DESCRIPTION: Ltr re our 6-13-75....trans the following: <u>DIST PER LA WILSON</u>	ENCLOSURES: Info concerning secondary system fluid flow instability in the Diablo Canyon design.... (15 cys encl rec'd)
PLANT NAME: Diablo Canyon 1 & 2

Diablo Canyon Units 1 and 2

Secondary System Fluid Flow Instability

Information Requested By NRC Letter Dated June 13, 1975

**PIPING ISOMETRIC DIAGRAM
 FEEDWATER PIPING TO STEAM GENERATORS**

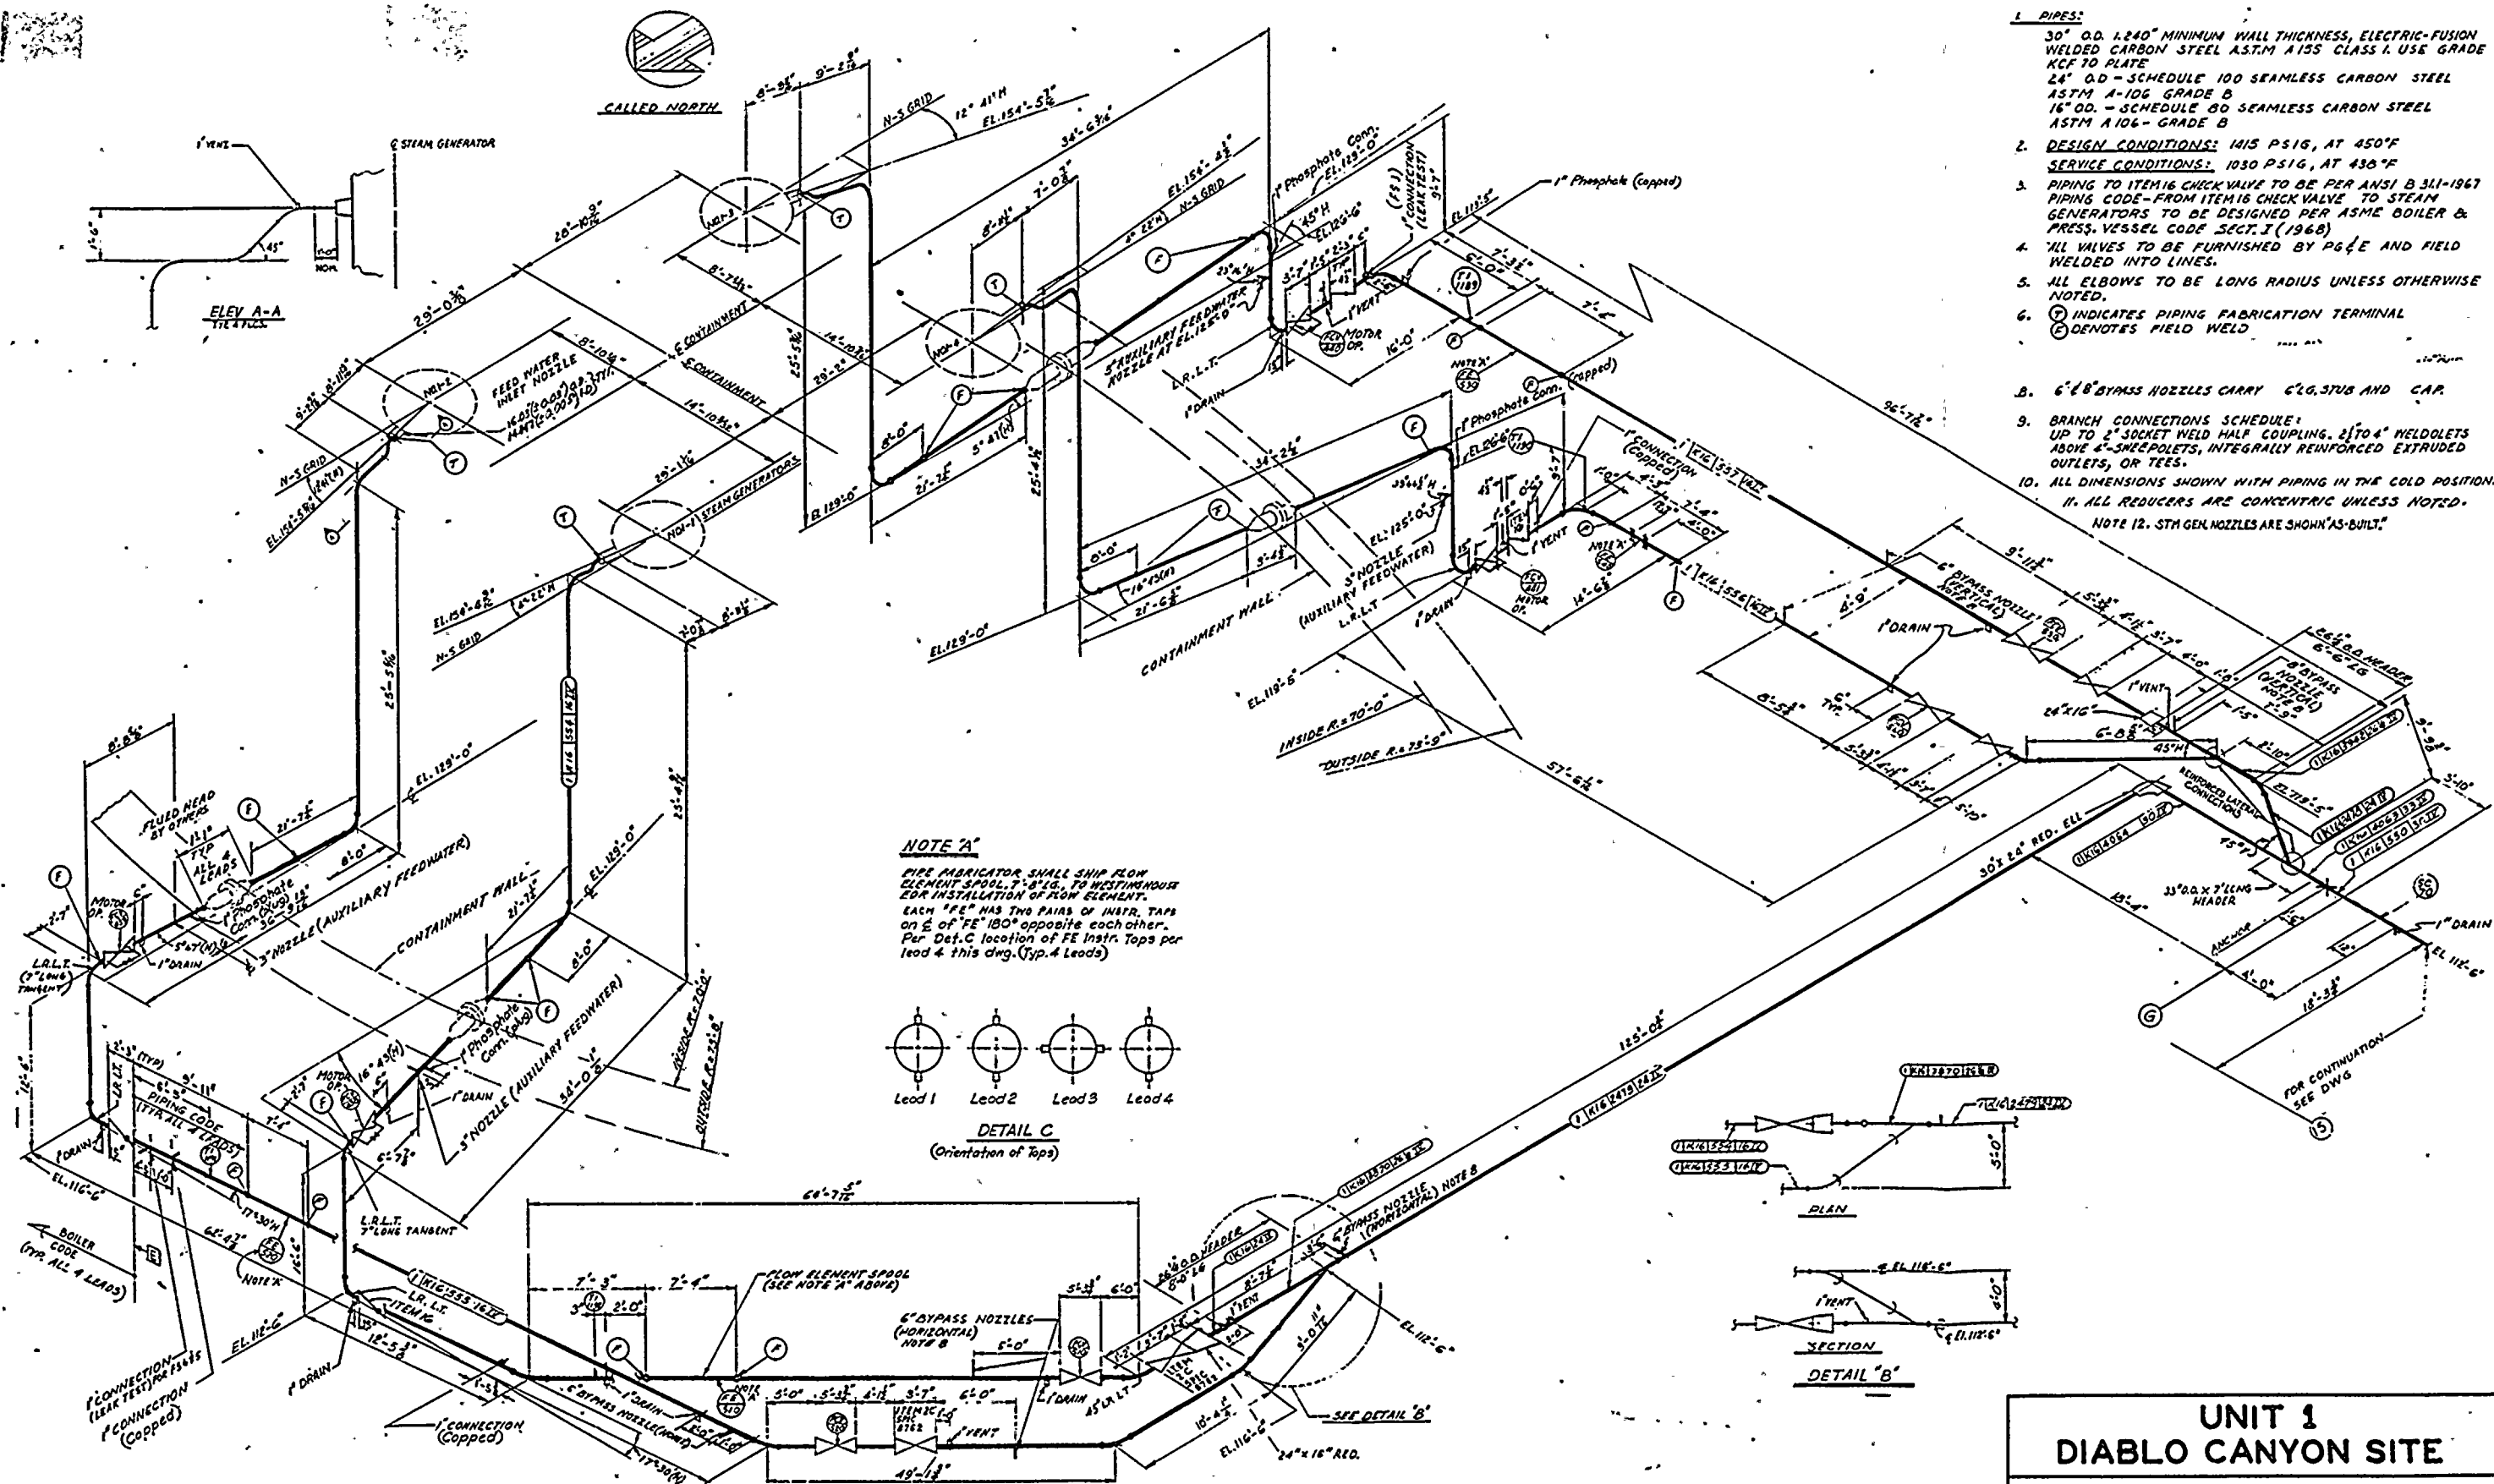
Question 2. Describe and show by isometric diagrams, the routing of the main and auxiliary feedwater piping from the steam generators outwards through containment up to the outer isolation valve and restraint. When describing the piping run, note all valves and reference continually, the elevation of the inlet nozzles and/or sparger with respect to the piping run elevation.

Response: Isometric diagrams of the routing of the main and auxiliary feedwater piping from the steam generators outwards through containment up to the outer isolation valve and restraint are attached. A schematic drawing indicating the supports and restraints for a typical feedwater line is attached also. The feedwater piping leaves all steam generators at a nominal elevation of 154'-4 1/16". One foot horizontally from the steam generator feedwater nozzle, the lines turn downward with 45° elbows. After passing downward at a 45° angle for approximately 5½ inches of pipe, the lines return to the horizontal thru a second 45° elbow. The lines are now at elevation 152'-10½", approximately 18 inches below the inlet nozzles. This portion of the lines pass thru the crane wall. The lines continue horizontally until they turn downward at 90° elbows. The vertical run of pipe is 8 feet 8 inches from the steam generator shell for steam generators 1 and 4 and 10 feet 9 inches from the steam generator shell for steam generators 2 and 3.
